Transport Assessment Second Addendum

Land north of Balcombe Road,
Haywards Heath

- 1.1.1 This addendum to the Transport Assessment (December 2025 ref. SDP-TA-131125-02) has been prepared following the response from West Sussex County Council dated 10th June 2026 providing further comments on the submitted documents. The response received can be found in Appendix A.

Date	06.02.25	Scale	1:500	Drawn	NM
Drawing No.	SDP-XX-XX-DR-D-352			Revision	P7

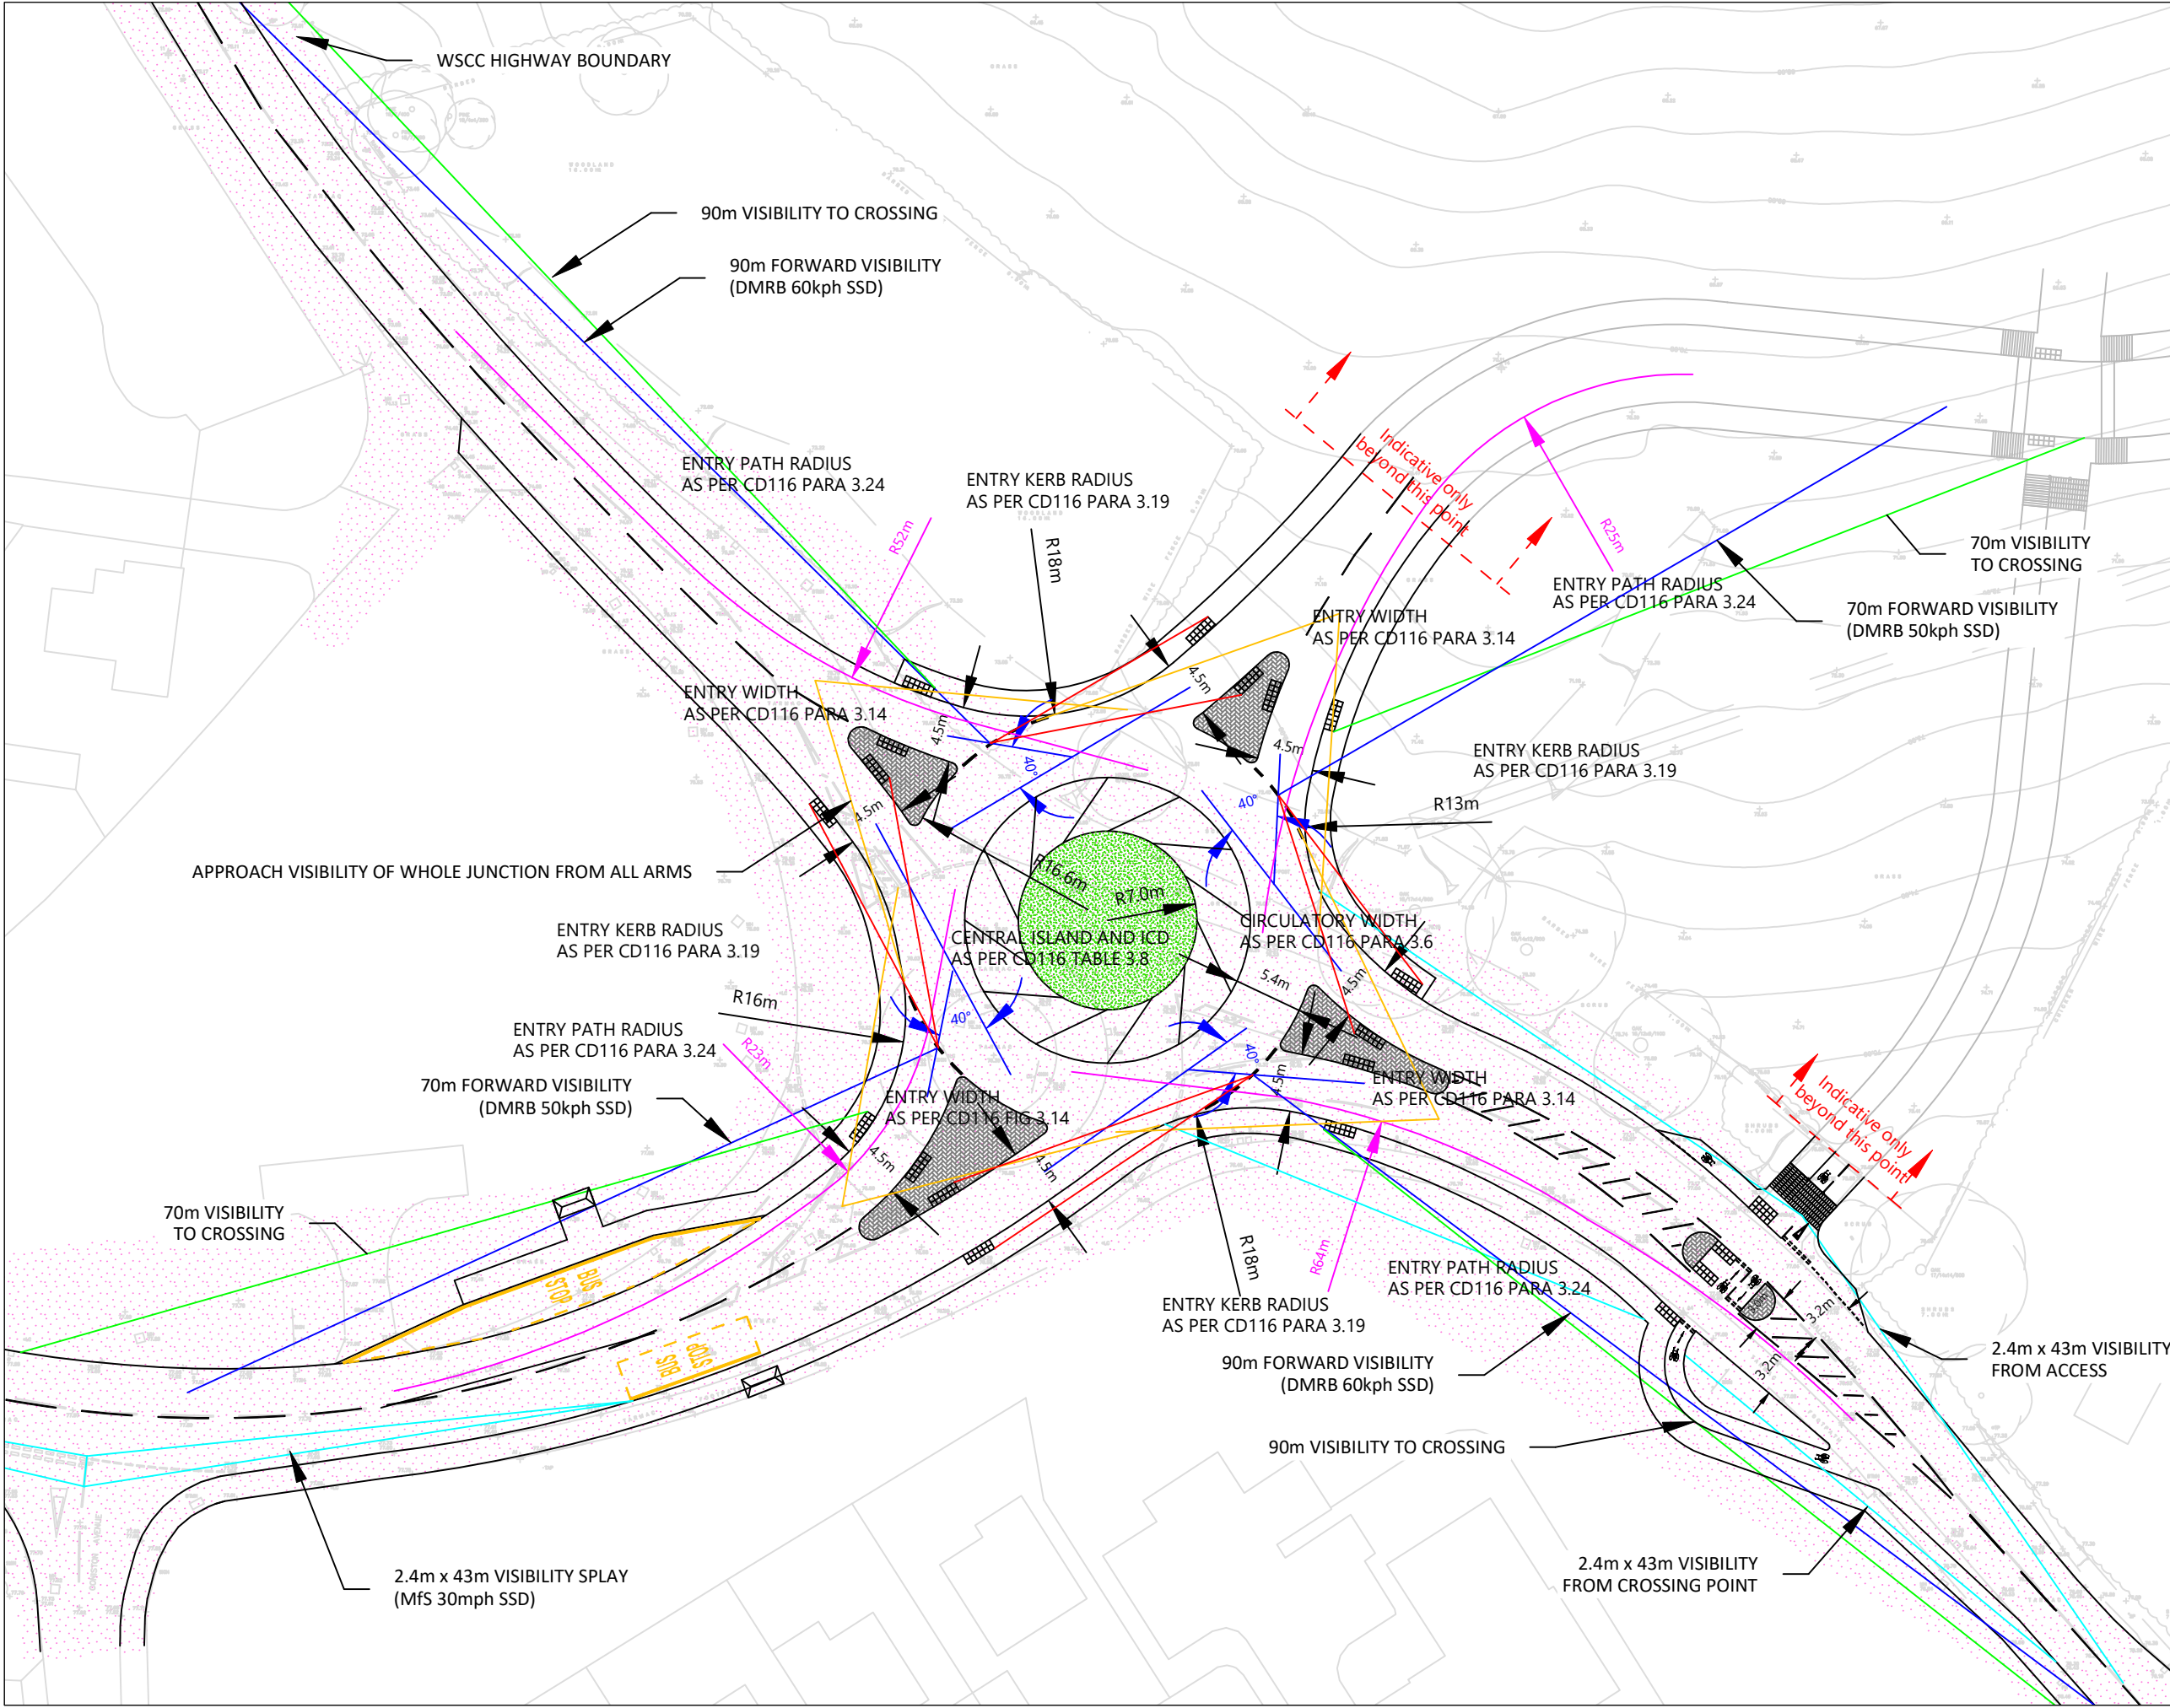
- 2.1.3 The geometric properties for each arm of the junction are shown on Drawing SDP-XX-XX-DR-D-352/P7 and presented in the Design Audit forming Appendix C of the Transport Assessment Addendum. The geometric properties and are summarised below:

- Design check of roundabout** - The view is that for roundabout designs, WSCC would ask for the design to be based on DMRB as the MfS is mute on how to design them. Where designers consider that MfS parameters are more appropriate on any arm, they can put this forward to be considered as a formal Departure from Standard requirements. This is the approach WSCC has taken previously for similar developments where the introduction of a fourth arm was proposed and is the principle WSCC adopts to get the reasons for adopting MfS on roundabouts recorded and approved. Therefore, you will need to apply for Departures from Standard for those elements you intend using MfS parameters on, including the development access. Attached is the form you will need to complete and send back to me. If there are multiple departures, you will need to complete a separate form for each one, please.

- 2.1.1 The roundabout design complies with DMRB criteria as set out in CD 116.
- 2.1.2 Visibility splays compliant with DMRB requirements for the desirable minimum stopping distances have been provided on all approach arms of the roundabout. Borde Hill Lane and Balcombe Road, with recorded speeds above 50 kph, adopt the 60 kph DMRB criteria. Hanlye Lane, with its lower recorded speed, and the development access adopt the 50 kph DMRB criteria. This gives a requirement for a desirable minimum SSD of 90m on Borde Hill Lane and Balcombe Road and a desirable minimum SSD of 70m on Hanlye Lane and the development access. The DMRB visibility splays are shown on Drawing SDP-XX-XX-DR-D-305/P9.

Entry widths	Proposed	CD 116 requirements
Borde Hill Lane	4.5m	Lane width of 4.5m should be used at single lane entries
Development access	4.5m	
Balcombe Road	4.5m	
Hanlye Road	4.5m

Entry angles	Proposed	CD 116 requirements
Borde Hill Lane	$\phi=20^{\circ}$	No less than 20 degrees and no greater than 60 degrees.
Development access	$\phi=20^{\circ}$	
Balcombe Road	$\phi=20^{\circ}$	
Hanlye Road	$\phi=20^{\circ}$

Entry kerb radii	Proposed	CD 116 requirements
Borde Hill Lane	18m	Not less than 10m or greater than 100m
Development access	13m	
Balcombe Road	18m	
Hanlye Road	16m

Entry path radii	Proposed	CD 116 requirements
Borde Hill Lane	52m	Shall not exceed 70m
Development access	25m	
Balcombe Road	64m	
Hanlye Road	23m

Exit widths	Proposed	CD 116 requirements
Borde Hill Lane	4.5m	Similar to entry widths
Development access	4.5m	
Balcombe Road	4.5m	
Hanlye Road	4.5m

Project			
Land north of Balcombe Road, Haywards Heath			
Title			
Bus Bay and Cycle Access Swept Path Analysis			
SDP			
Bunton Barn, Bunton Lane Bolney, West Sussex, RH17 5RE			
Date	11.06.26	Scale	1:500 / 1:200
Drawn	NM		
Drawing No.	SDP-XX-XX-DR-D-357	Revision	P1

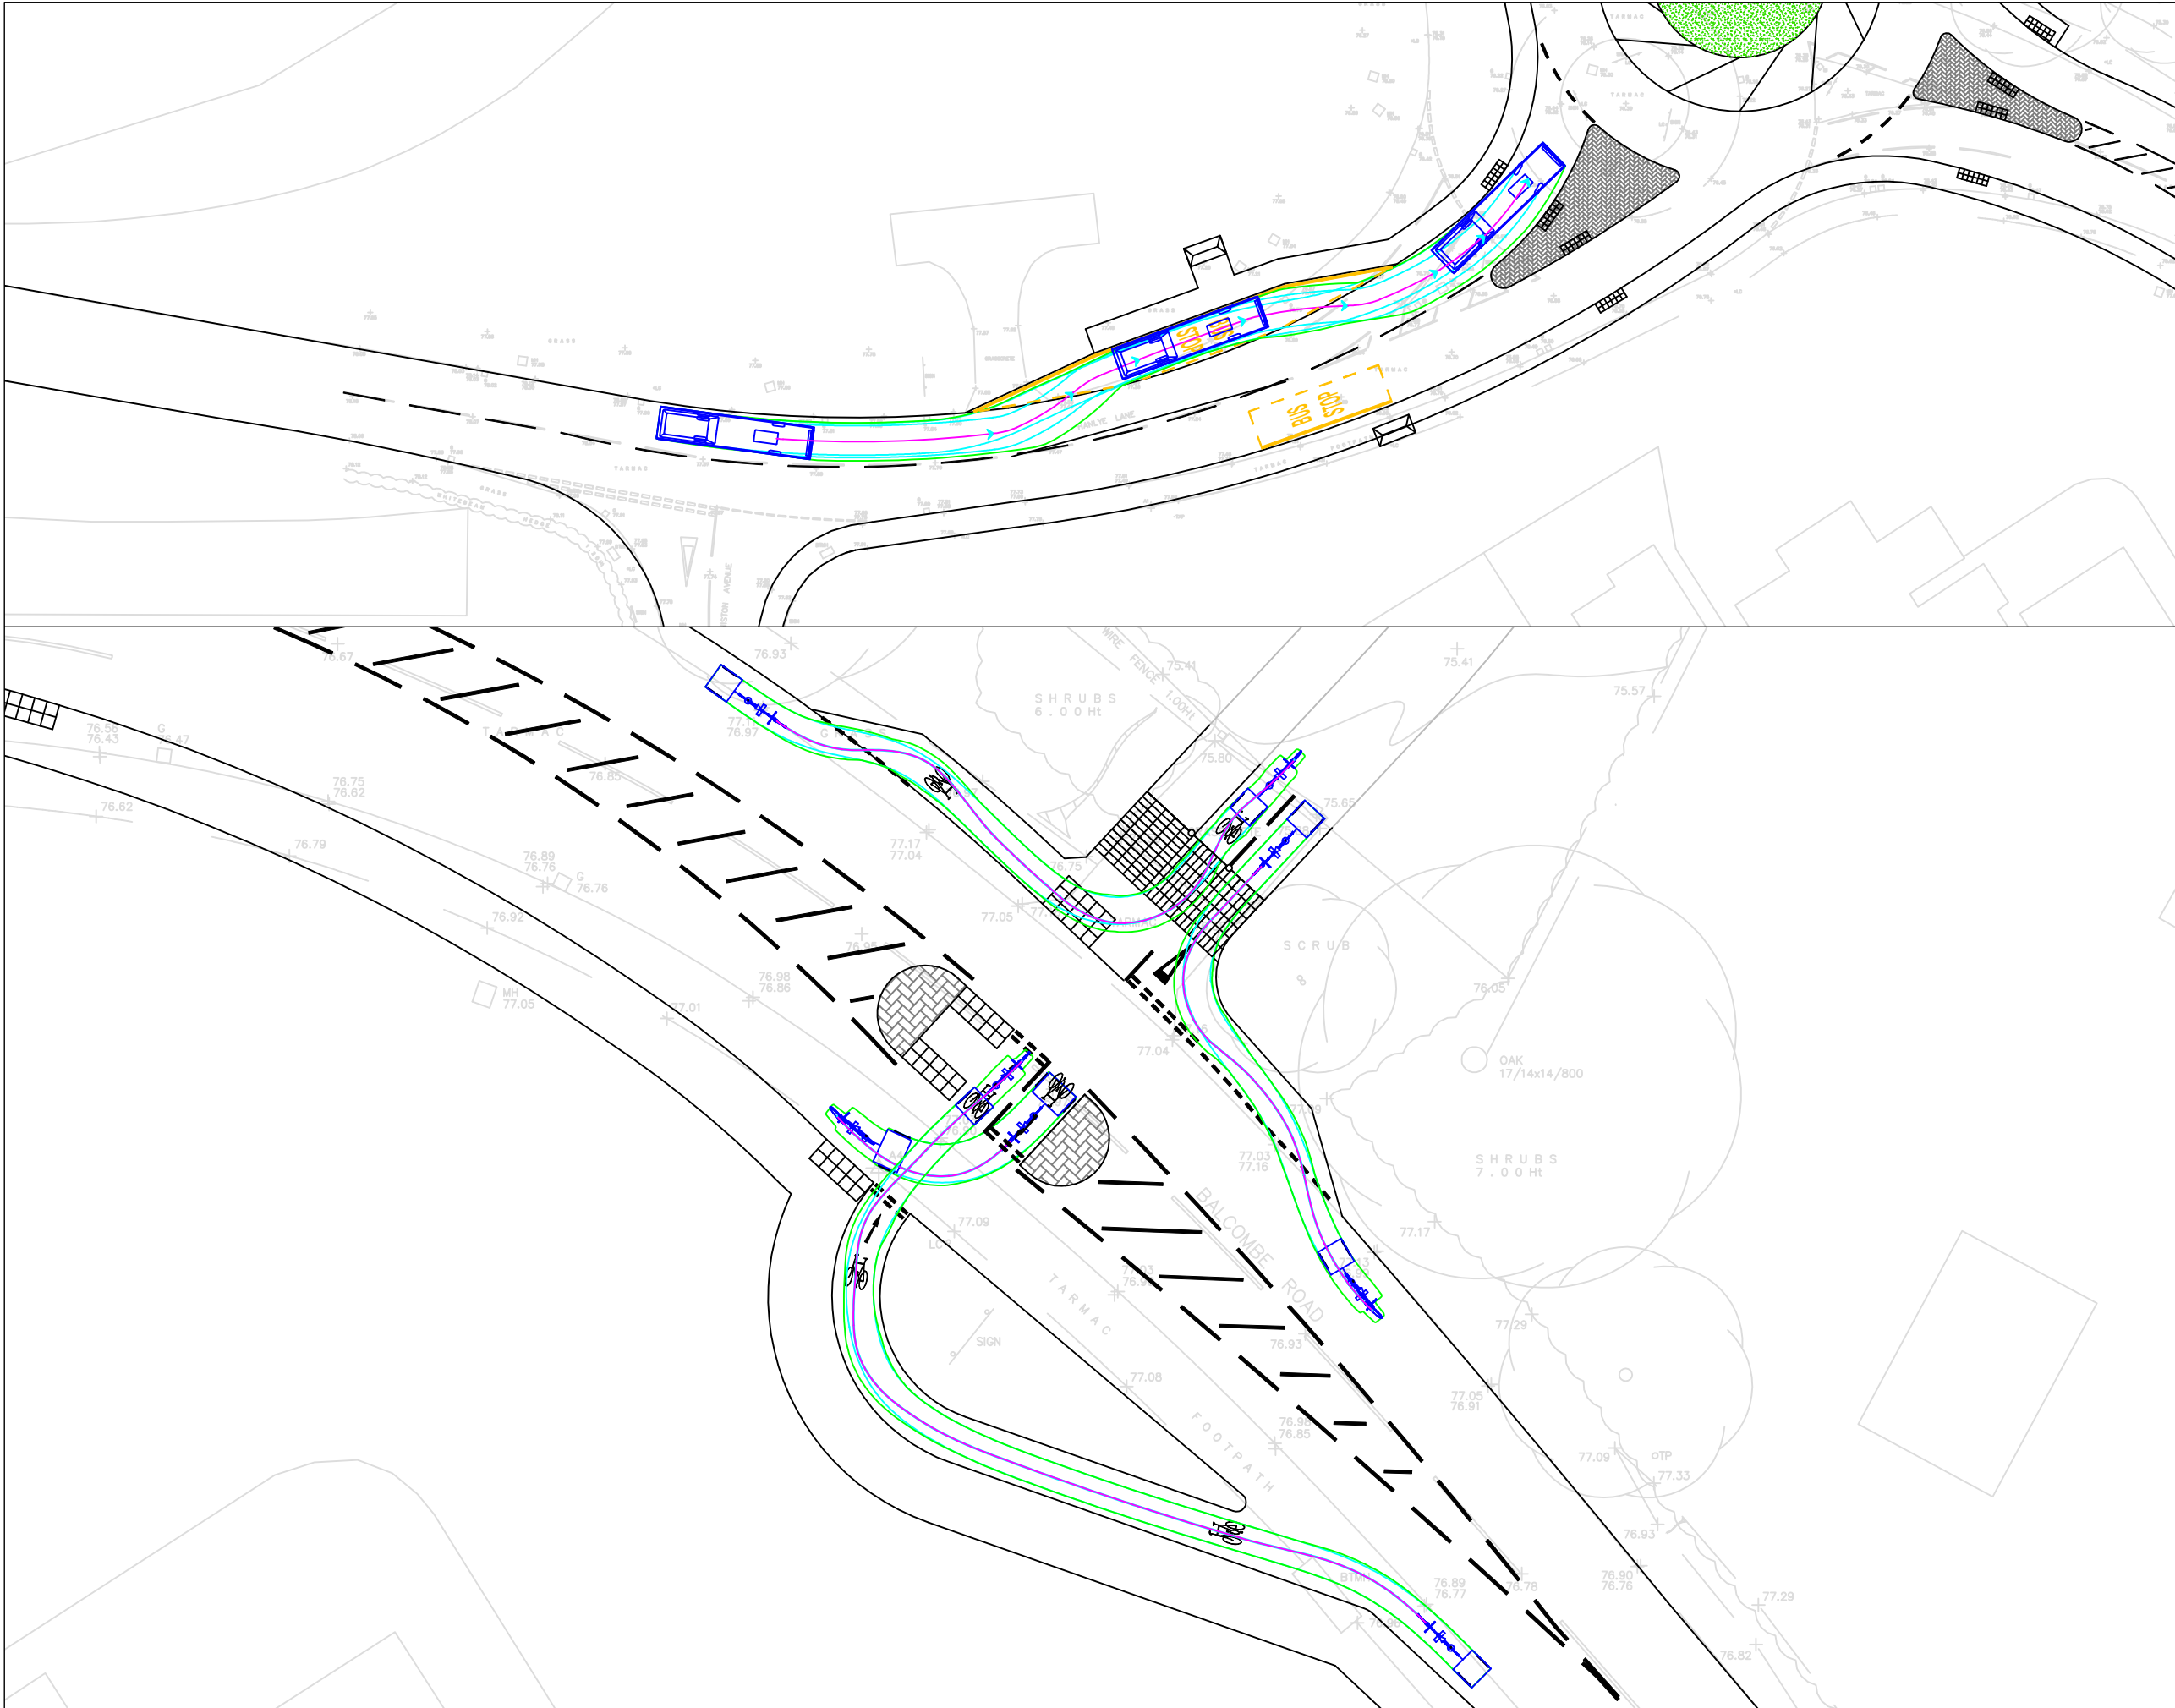
Also, the overrun seems wide. Is it required by swept paths? A narrower one is likely to attract fewer overruns by small vehicles.

- 3. Cycle provision** – WSCC requires that a 'jug handle' arrangement is provided on the opposite (southern) side (the RSA raises this, too). Please would you update your plan. Please would you also re-visit how cyclists would enter and leave the carriageway on the eastern side of the road, which is another point raised in the RSA. With regard to lane widths, WSCC would rather the lane widths go in at 3.2m which not only follow WSCC Standard Construction Details, but will also mean that there will be a slightly greater margin between vehicles and peds/cyclists using the refuge. Additionally, it should also permit snow ploughs to negotiate the routes too. As the RSA makes reference to the widths, I will have to prepare an 'Exception' report. A copy of the updated DRAFT Decision Log will follow once I have sent a copy to my road safety colleagues to look at and then heard back from the same.

- 2.5.2 Cycle slip lanes have been added on the southbound carriageway to allow cyclists to leave the carriageway before turning, and to assist cyclists in joining the main carriageway when heading south from the site. Swept path analysis of a cycle with a trailer is shown on Drawing SDP-XX-XX-DR-D-357/P1.

- 2.6.2 The Road Safety Audit recommended that the eastbound bus stop on Hanlye Lane be inset due to the curvature of the carriageway increasing the risk of head-on collisions should any vehicle choose to overtake a stationary bus. Drawing SDP-XX-XX-DR-D-305/P9 shows the option of an inset bus stop which removes the need for vehicles to overtake stationary buses on the carriageway. Swept path analysis for the bus bay is shown on Drawing SDP-XX-XX-DR-D-357/P1.
